# UNITED STATES PATENT AND TRADEMARK OFFICE

10/797,255

Brian P. Roarty

<b>Office Action Summary</b>	<b>Application No.</b> 10/797,255	<b>Applicant(s)</b> ROARTY, BRIAN P.	
	<b>Examiner</b> Erin M. Boyd	<b>Art Unit</b> 3663

Gray French; Figure 1, page 67

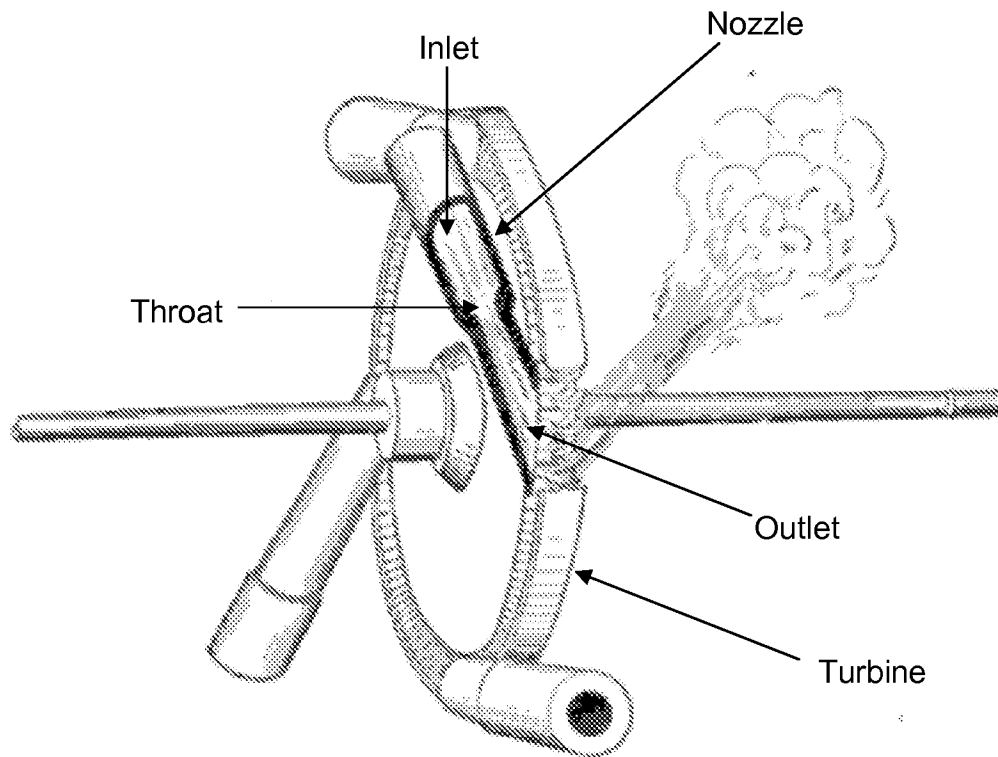
24. Regarding Claim 4, Gray French teaches a system comprising a nozzle having an inlet, a throat, and an exhaust (see figure below); a fluid flowing through the nozzle; and a means (i.e. turbine) for transforming the flow from the exhaust into work outside the system. Gray French fails to teach a means embedded within the nozzle for transferring energy into and heating the nozzle, thereby indirectly transferring energy into and heating the fluid and inducing a phase change in the fluid. Patterson teaches a means 38/44/36 embedded within a nozzle 12 for transferring energy into and heating the nozzle 12 (column 2, lines 15-17); thereby indirectly (through means 36) transferring energy into and heating the fluid and inducing a phase change in the fluid (column 3, lines 59-60).

A motivation for indirectly supplying energy to the fluid in the manner above described is to form the necessary electrolytic current flow path between the cathode 38

and anode 44 (U.S. Patent No. 5,318,675; Patterson, column 5, lines 56-59). Thus, it would have been obvious to one of ordinary skill in the art at the time of the invention to embed said means 36 in the nozzle 12.

**25.** Regarding Claim 5, Gray French teaches a system wherein the cross-sectional interior volume of the inlet, throat, and exhaust of the nozzle vary only across one plane perpendicular to the axis of the fluid flowing through the nozzle (see figure below).
